Access Compliance Report

Public Rights-of-Way

(Curb Ramps)

Intersection ID: 10035599	Main Street: REAMES_RD	Cross Street: N/A	Location: W
ADA ID: 43EF9BDCD108	Ramp Type: Perp	Initial Pass/Fail: Pass	Overall Compliance: No
Codes/Mitigation Info/Possible Solution		Field Measurements/Component Compliance	
Severity Score: 2.75

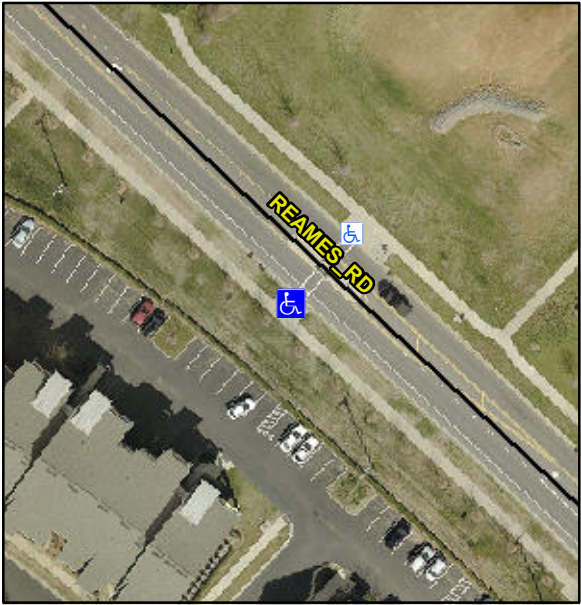
Possible Solutions:						
	Remove & Replace Entire Ramp.	N/A	Ramp Length (in)	96.0	Yes	Ramp Slope (%)	7.9
	Remove & Replace Gutter.	Yes	Ramp Width (in)	48.0	No	Ramp XSlope (%)	2.9
		N/A	Flare Type LT	Sloped	N/A	Flare Type RT	N/A
		N/A	Flare Slope LT (%)	12.0	Yes	Flare Slope RT (%)	3.5
		N/A	Flare Traversable LT?	Yes	N/A	Flare Traversable RT?	Yes
		Yes	Landing Length (in)	71.0	Yes	DWS Provided?	Yes
		Yes	Landing Width (in)	78.0	Yes	DWS Contrast?	Yes
		No	Landing Slope (%)	2.1	Yes	DWS Length (in)	24.0
		No	Landing X Slope (%)	3.0	Yes	DWS Full Width?	Yes
<p>Surveyor Notes:</p> <p>N/A</p> <p>PROW/ADA:</p> <p>R304.5.3, R304.2.2-Perp, R304.3.2-Para, R304.2.3</p>		N/A	Landing Curb? (Y/N)	No	Yes	DWS Offset (in)	2.0
		N/A	Shared Landing?	No			
		Yes	Gutter Ponding?	No	Yes	Gutter Slope (%)	4.5
		Yes	Gutter Lip Ht (in)	0.0	No	Gutter X Slope (%)	2.9
		N/A	Painted X Walk1?	Yes	N/A	Painted X Walk2?	N/A
			X Walk 1 Direction	To NE		X Walk 2 Direction	N/A

N/A	X Walk 1 Width (in)	60.5	N/A	X Walk 2 Width (in)	N/A
			X Walk 1 Slope (%)	5.7		X Walk 2 Slope (%)	N/A
			X Walk 1 X Slope (%)	2.5		X Walk 2 X Slope (%)	N/A
		Yes	Ramp inside XWalk1?	Yes	N/A	Ramp inside XWalk2?	N/A
<p>Street 1 Name</p> <p>Stop Condition-Street 2</p> <p>Street 2 Name</p> <p>Stop Condition-Street 1</p>			Road Slope (%)	N/A	N/A	Clear Space?	Yes
			Road X Slope (%)	N/A	N/A	Clear Space to XWalk (in)	N/A
		Yes	Any Obstructions?	No	Yes	Storm Grate/Utility Hazard?	No
			Obstruction Type			Storm Grate/Utility Type	
					N/A		N/A
					Yes	Surface Condition? (G/P)	Good
Total Cost:		\$	2600.00
